ADDENDUM

PROJECT: Cherokee Regional Medical Center
Emergency Department Addition
& Surgery / CS Remodel
Cherokee, Iowa

AD-1

DATE ISSUED: Thursday, April 5, 2012

Drawing # C-102.1

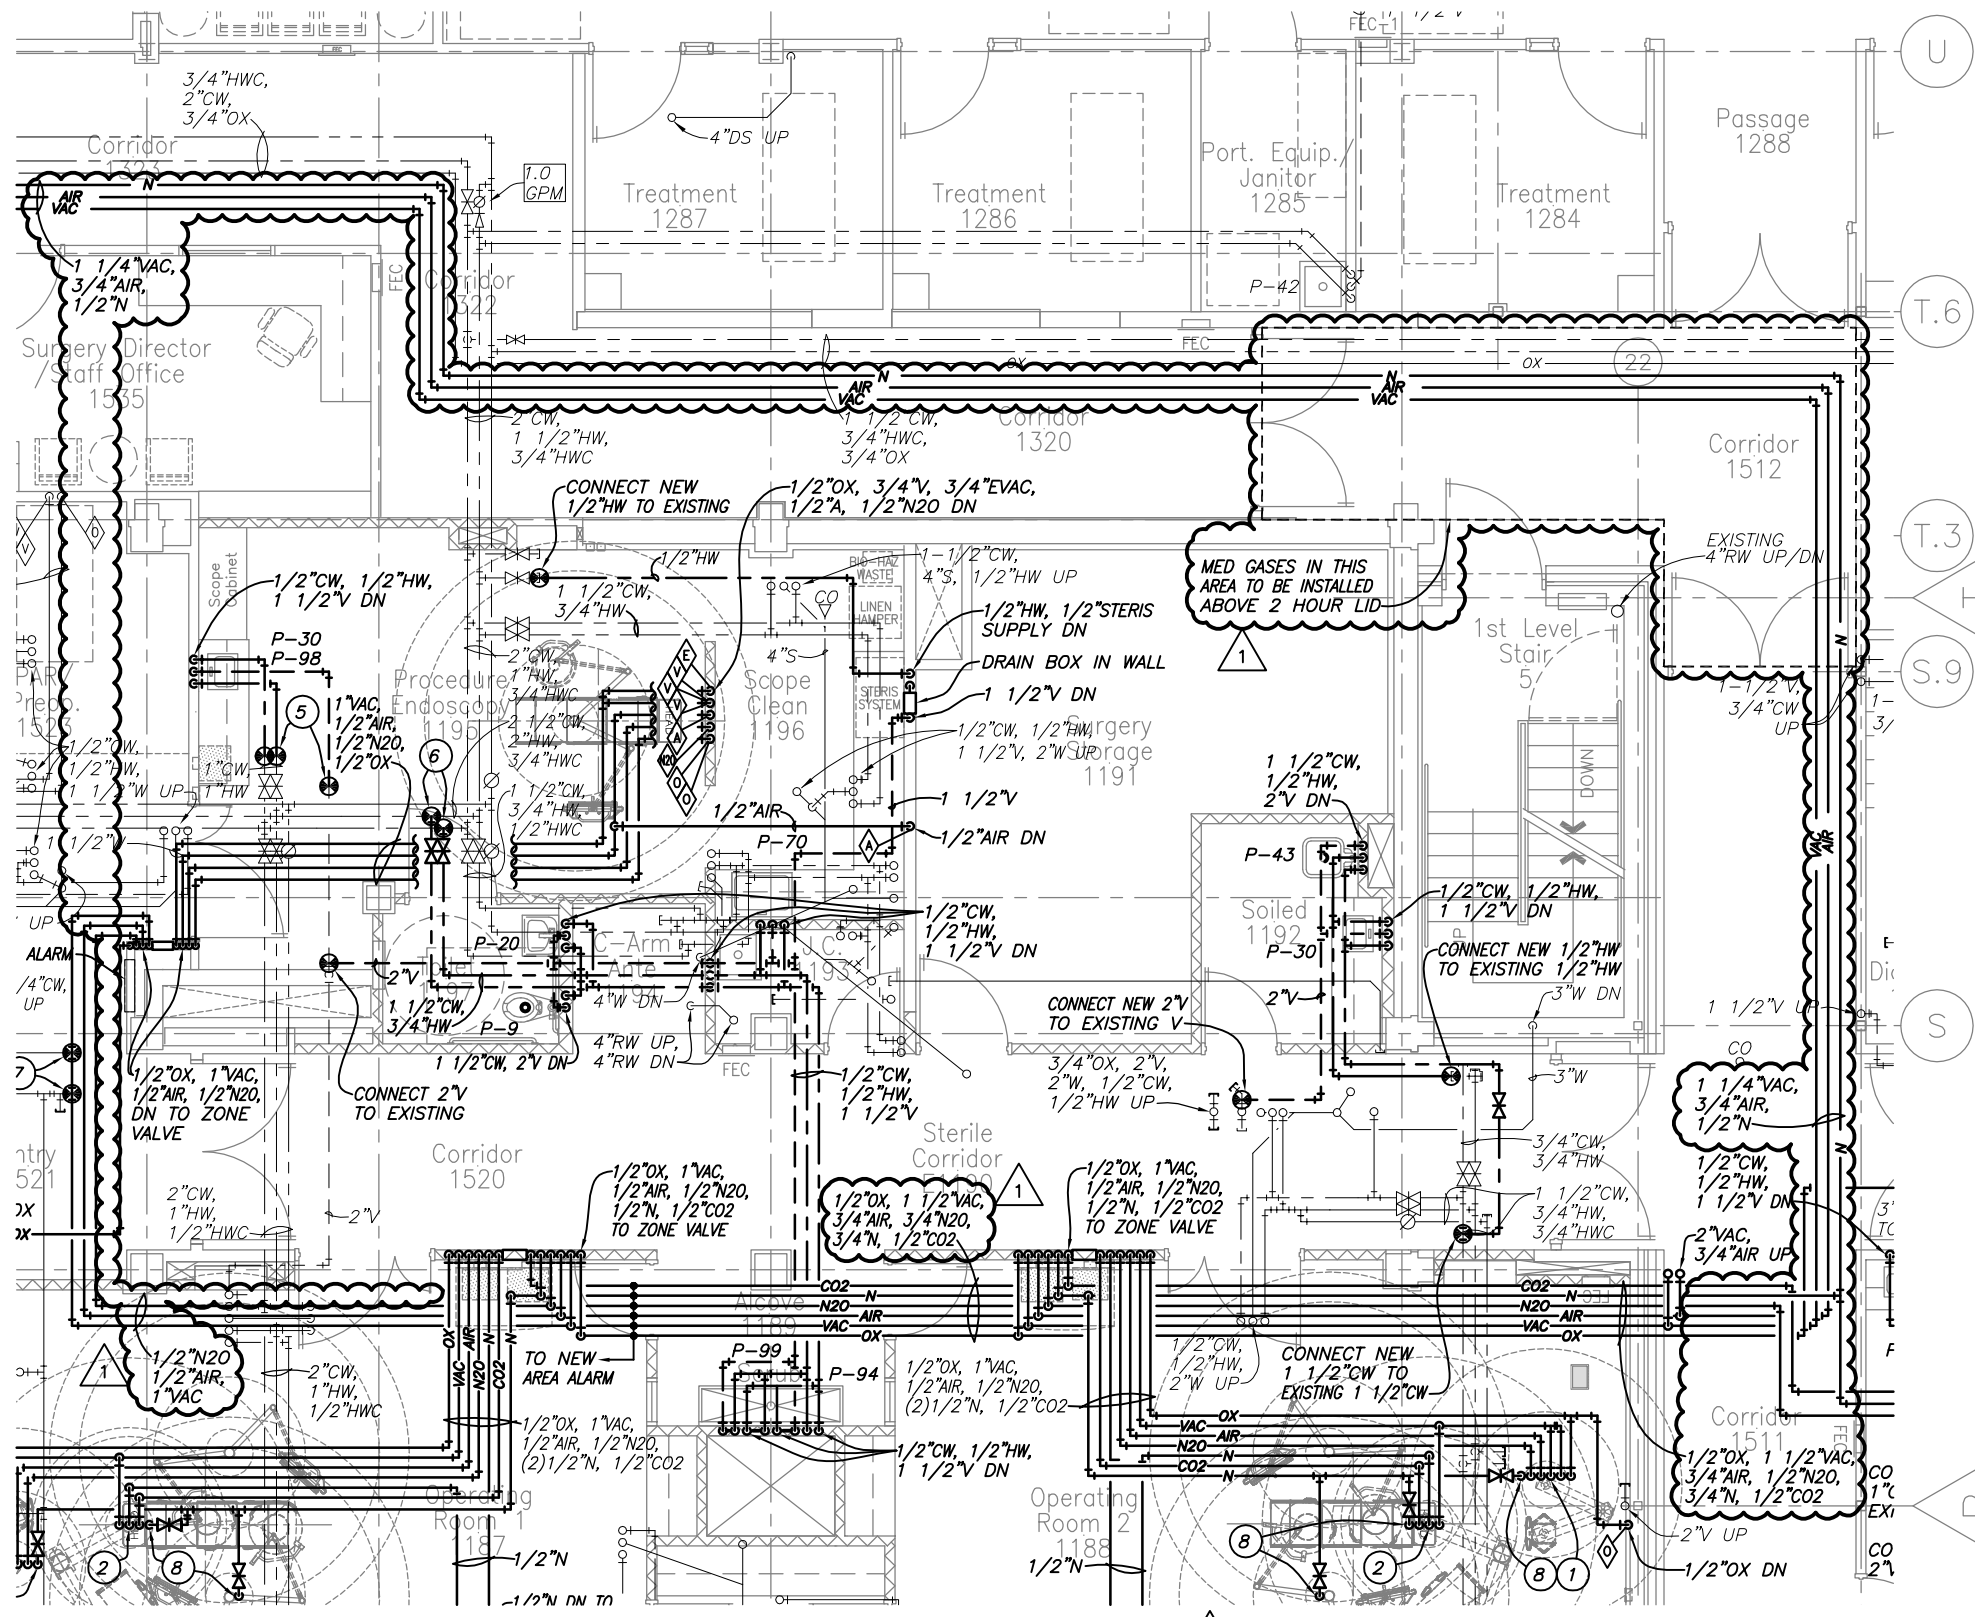
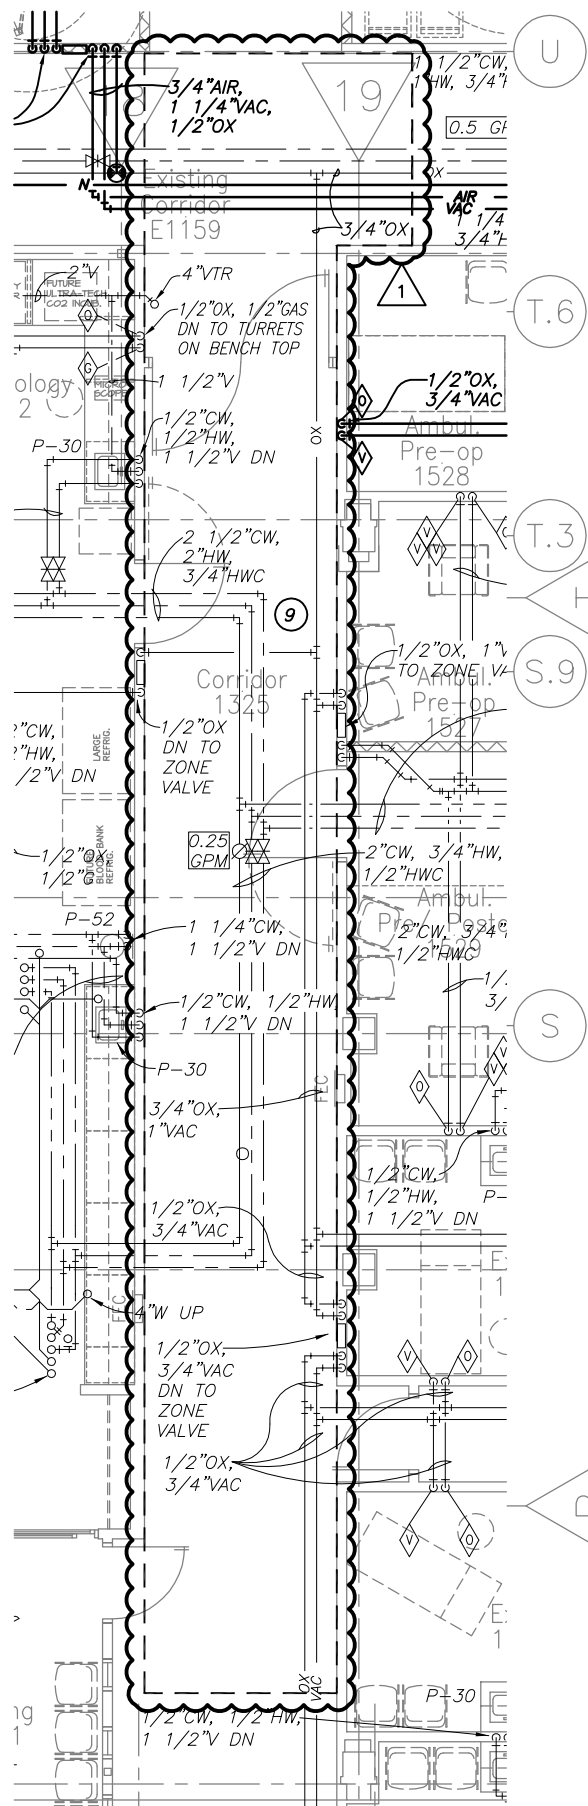
In reference to drawing **Sheet C-102 – Site Grading Plan**, See supplemental drawing C-102.1 showing addition to dry-stack retaining near new driveway at existing garage.

Site Grading Plan - Garage Retaining Wall Addition

Issue Date	04-05-2012
Job #	11-0212
Drawn by:	EMA
CADD file:	P-101.dwg
COPYRIGHT © DAVIS DESIGN ALL RIGHTS RESERVED	
Drawing Title Partial First Floor Plumbing Plans	
From Sheet:	for CA use:
P-101	
Drawing #	P-101.1

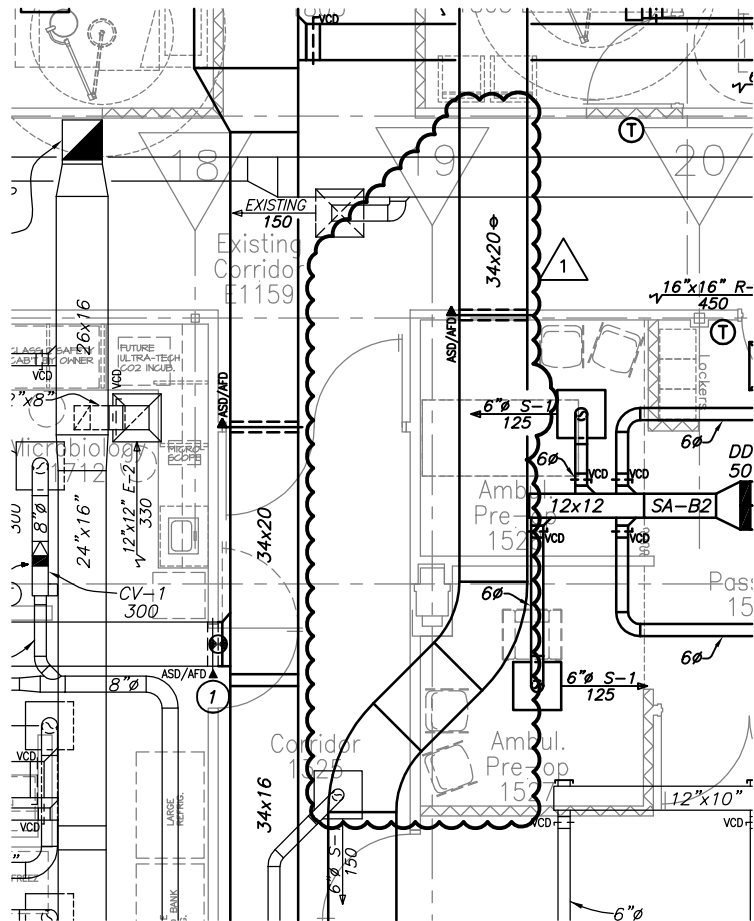
In reference to drawing Sheet P-101, see attached Supplemental Drawing P-101.1.

1 EXISTING PLUMBING IN THIS AREA TO BE REWORKED FOR INSTALLATION OF NEW DUCTWORK.

Drawing #
 M-101.1

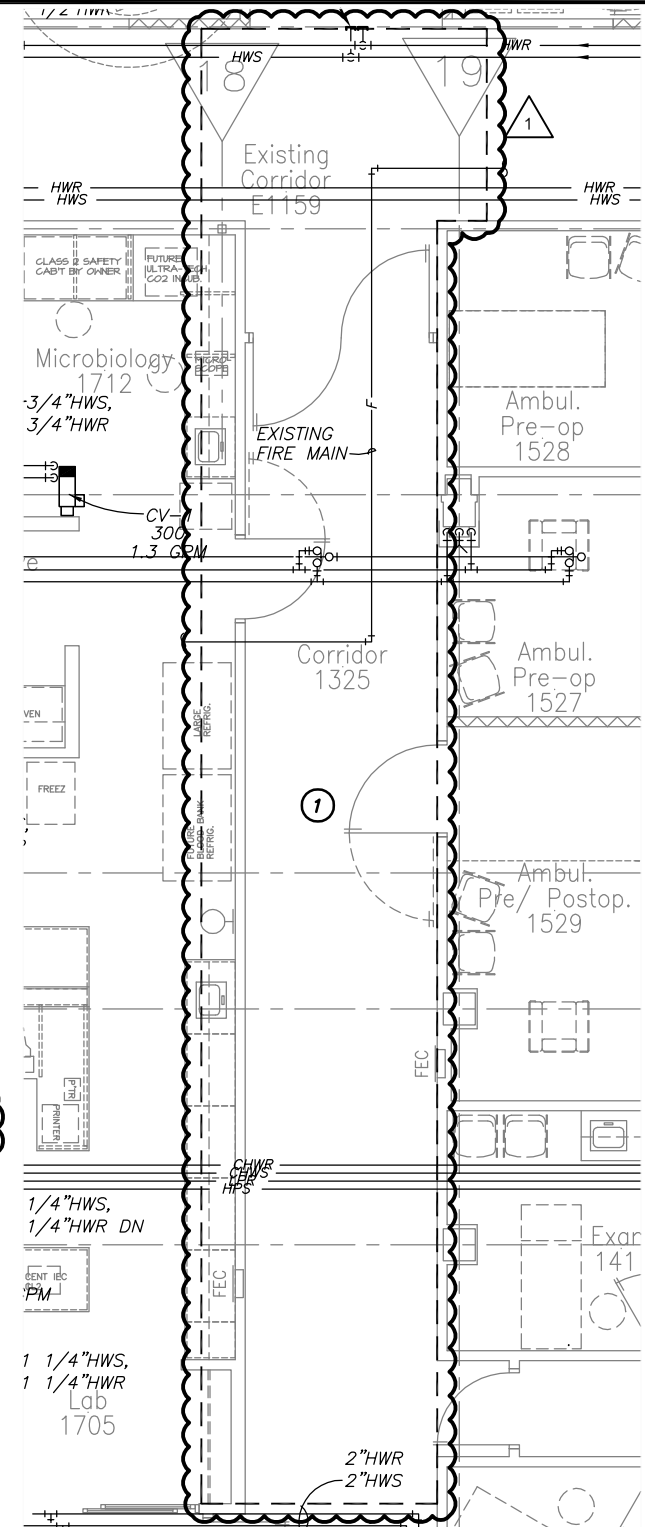
In reference to drawing Sheet M-101, see attached Supplemental Drawing M-101.1.

Drawing #
M-103.1

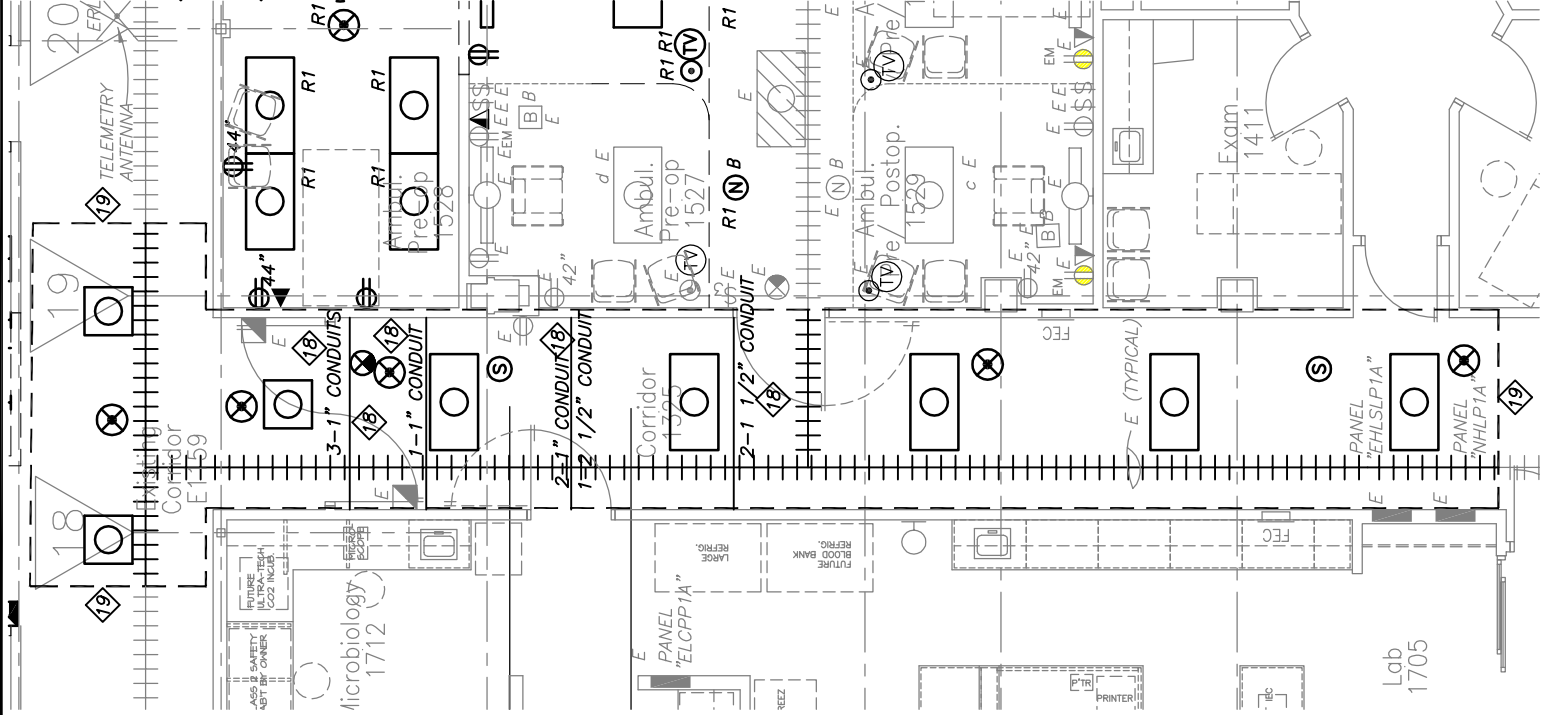
In reference to drawing Sheet M-103, see attached Supplemental Drawing M-103.1.

1 EXISTING HYDRONIC PIPING AND FIRE SPRINKLER PIPING AND HEADS IN THIS AREA TO BE REWORKED FOR INSTALLATION OF NEW DUCTWORK.

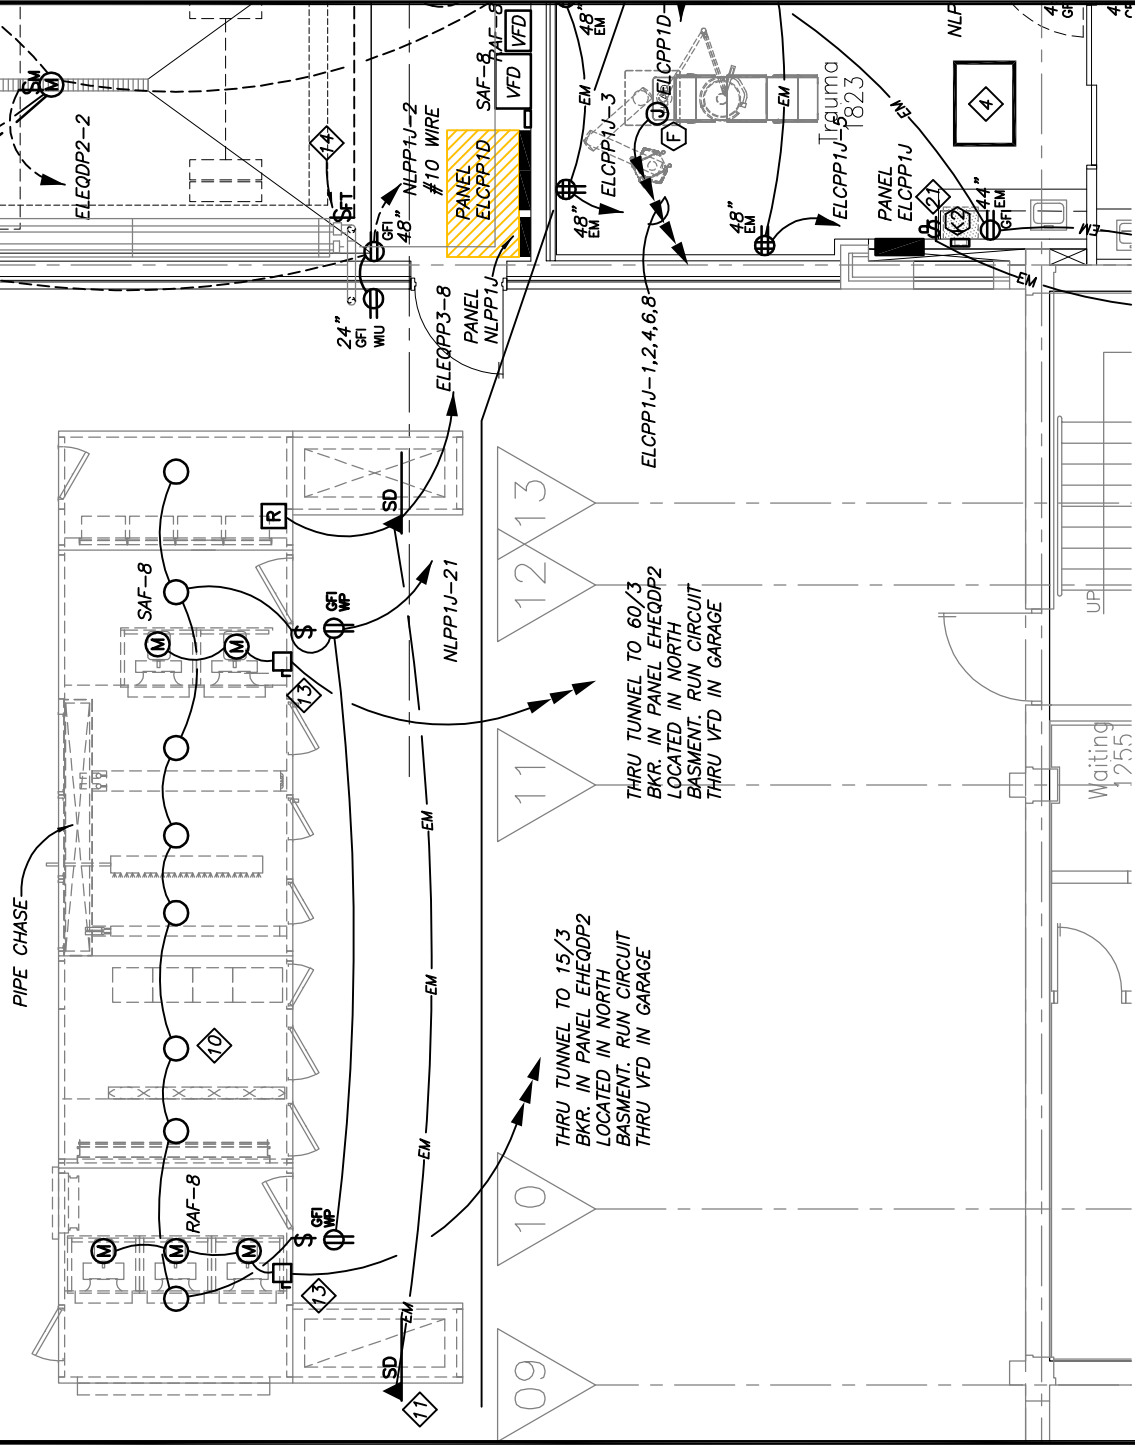
In reference to drawing Sheet E-104 – North First Floor Electrical Power Plan, See supplemental drawing E-104.1 for AHU-8 location clarification.

AHU-8 LOCATED ON ROOF OF NEW ADDITION.
 LOCATION SHOWN AS IS FOR CLARITY OF OTHER
 ELECTRICAL IN ROOMS BELOW. SEE MECHANICAL
 SHEET M-101 FOR LOCATION ON ROOF.
